Model 375XL

Reduced Pressure Principle Assembly

Shop Drawing Submittal Review

Project Name: Webster University-**ISB**

BFP-3 BACKFLOW PREVENTER PER ADDENDUM #2-1

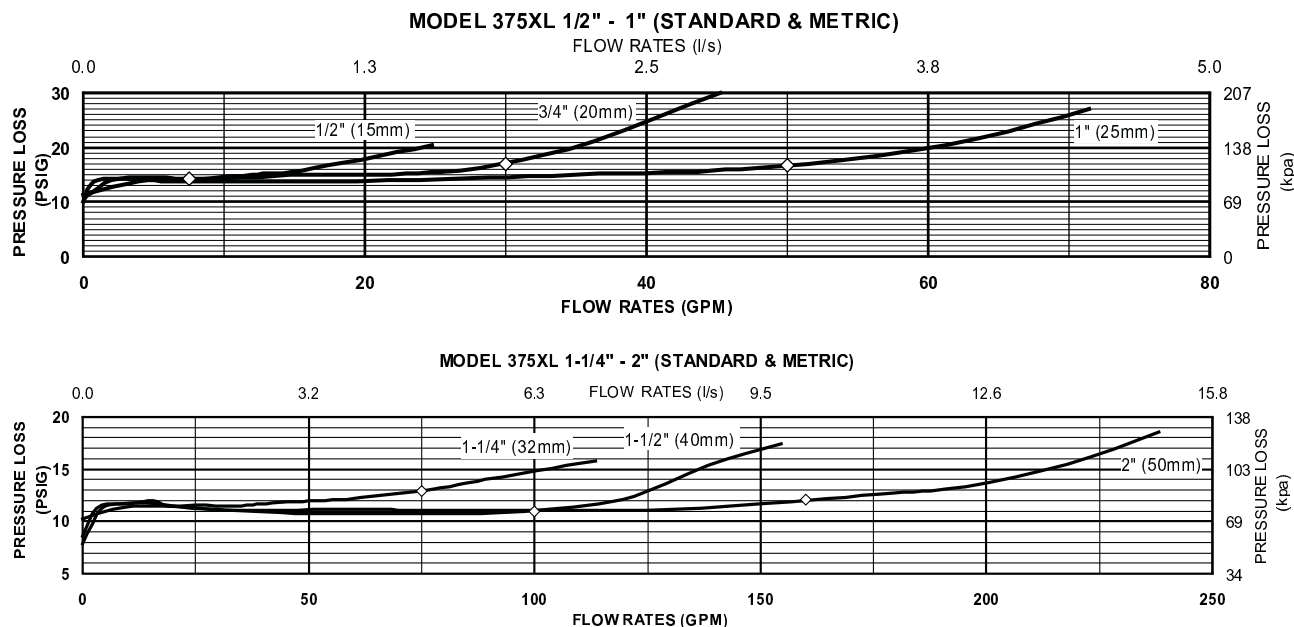
1. BFP-3 - Provide caps and tethers for each test cock.
